# SAN FRANCISCO PLANNING DEPARTMENT

**MEMO**

## Appeal of Final Environmental Impact Report SFPUC Alameda Creek Recapture Project

**RE:** Board of Supervisors File No. 170893, Planning Case No. 2015-004827ENV  
Appeal of the Certification of the Final Environmental Impact Report on the SFPUC Alameda Creek Recapture Project

SFPUC Alameda Creek Recapture Project  
**Figure 5.16-12**  
Geologic Cross-Section for ACRP Project Vicinity

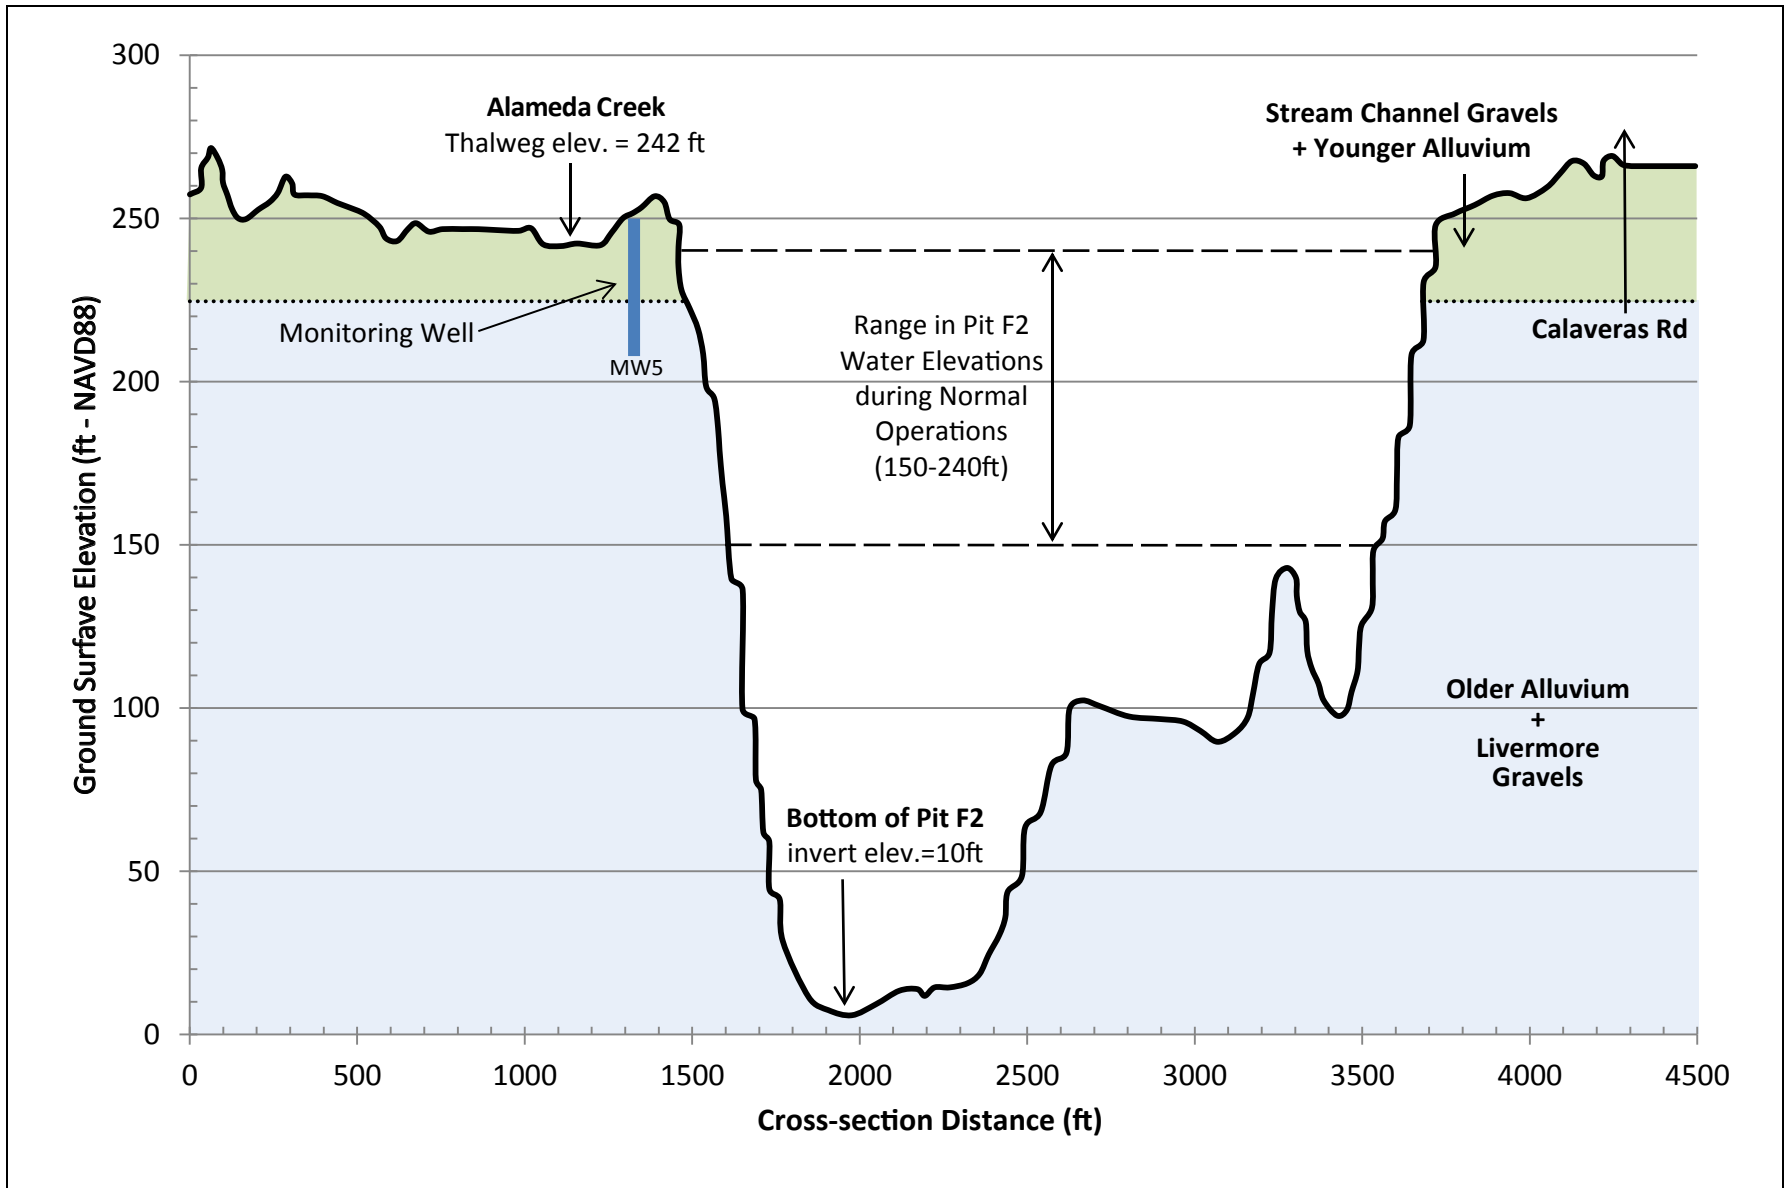
Comment A-19 further states that "the ASDHM modeling assumes that under project conditions the loss rate of surface water from Alameda Creek will not change relative to current conditions, when in reality the project will lower local groundwater levels and increase surface water loss rates, which will impact downstream flow rates." Comment E1-6 states "the modeling analysis makes no effort to reflect changing stream losses, nor are changing stream losses reflected in the FEIR's impact analysis." Neither of these assertions is valid for the reasons described below.

The Appellant is incorrect in stating that the project will lower local groundwater levels and increase the rate at which surface water percolates into the subsurface because of the physical characteristics of the Sunol Valley Groundwater Basin (describe below under *EIR Groundwater Model*). In summary, local “groundwater” in the study area occurs almost entirely within the shallow alluvium, and this groundwater is more aptly referred to as underflow to Alameda Creek. The shallow alluvium is underlain by Older Alluvium and Livermore Gravel formations that do not transmit groundwater to any significant degree on the valley floor. Surface water that collects in Pit F2 and other quarry pits occurs primarily as a result of seepage from Alameda Creek through alluvial materials that transmit underflow. The underflow seeps into the quarry pits if the elevation of water in the quarry pits is lower than the lowest elevation of the shallow alluvium, which is what typically occurs. When the pit is full and the water level in the pit is higher than the elevation of the underflow, water will seep from the pit back into the shallow alluvium.

Pit F2 is about 240 feet deep. Near Pit F2, the shallow alluvium is approximately 25 feet in thickness. Underlying these alluvial materials are the impermeable Older Alluvium and Livermore Gravels formations that are high in clay content and the primary targets for aggregate mining in the Sunol Valley. Pit F2 extends 25 feet through the shallow alluvium and another 215 feet through these deeper impermeable Older Alluvium and Livermore Gravels (see **Figure 5.16-12** from the EIR, shown on the following page). Only the upper ten percent of Pit F2 is hydrologically connected to the shallow underflow from Alameda Creek, and the large majority of water collected in Pit F2 is stored below the contact with the deeper impermeable geologic materials.
